CITY OF ALBUQUERQUE

RE: 8920 Oakridge Court
Grading Plan
Stamp Date: 6/27/17
Hydrology File: C20D077

| | GRADING AND DRAINAGE PLAN | | DATE 6-23-17 |

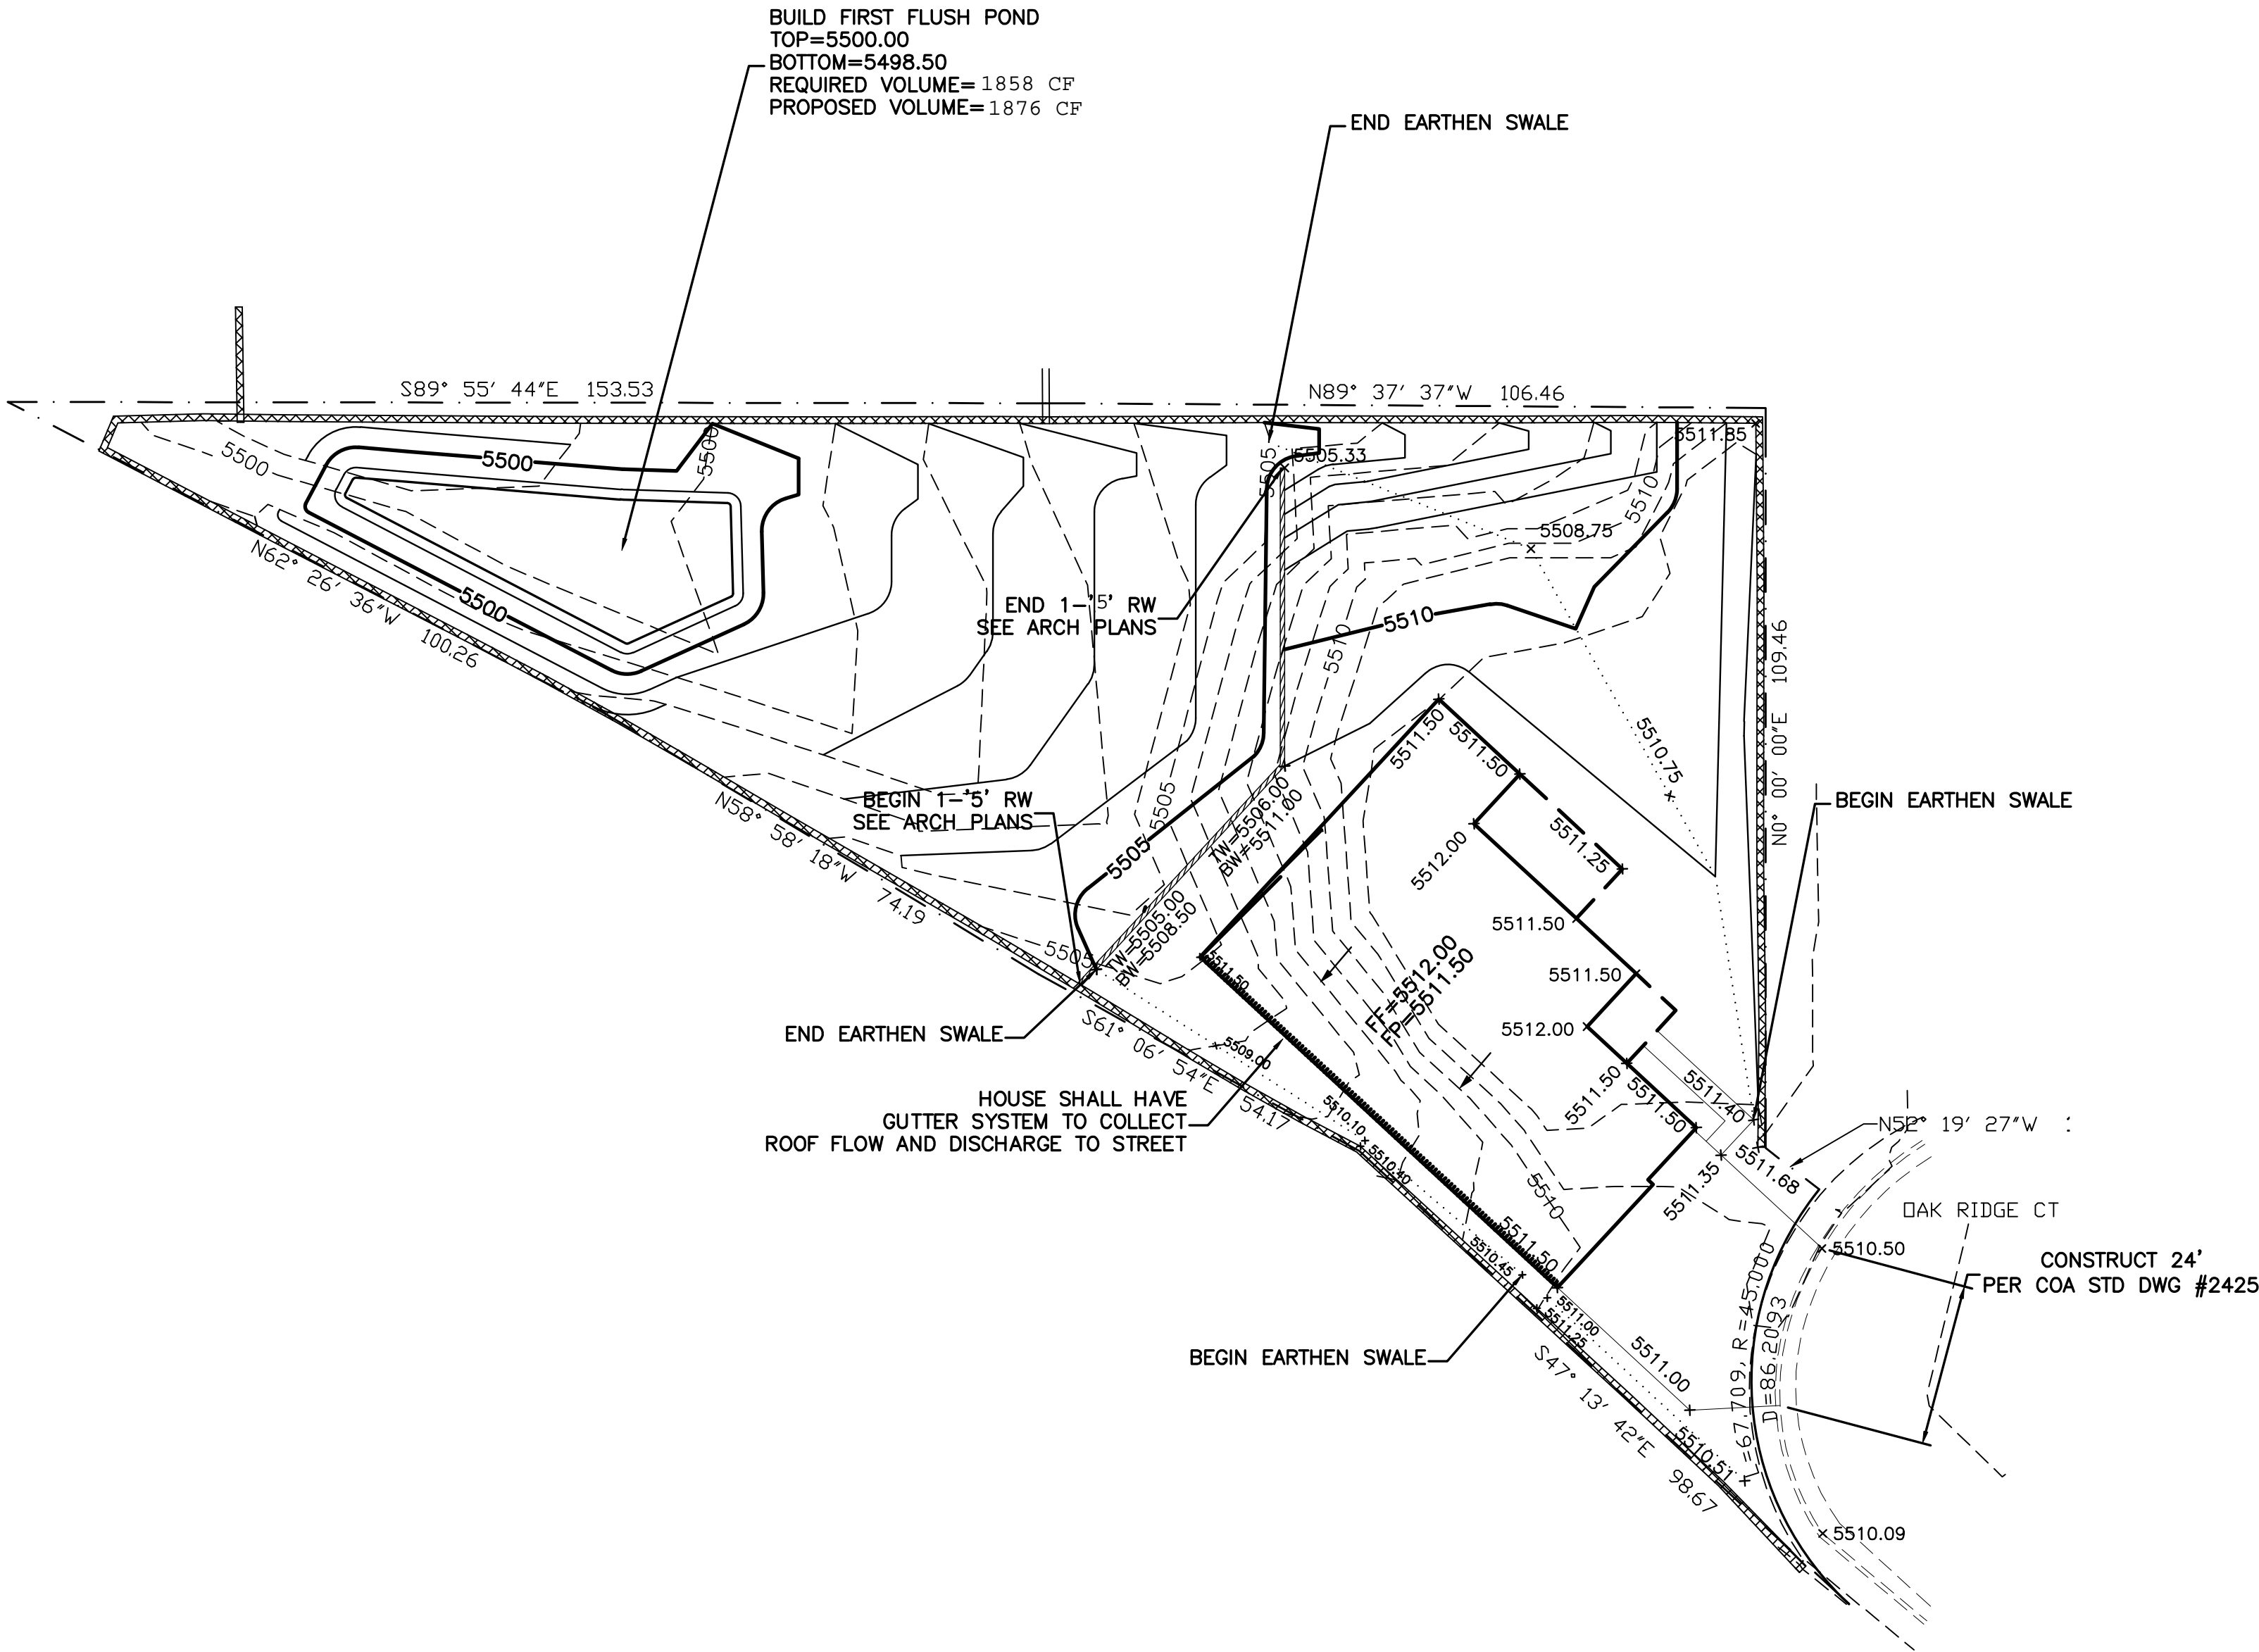
1. Please provide the description "La Cueva Channel (maintained by AMAFCA)" to the tract to the southwest of the property.
2. Since the site drains into the La Cueva Channel, approval by AMAFCA will be need prior to Hydrology approval. Please contact Bradley Bingham, PE at (505) 884-2215 or bbingham@amafca.org.
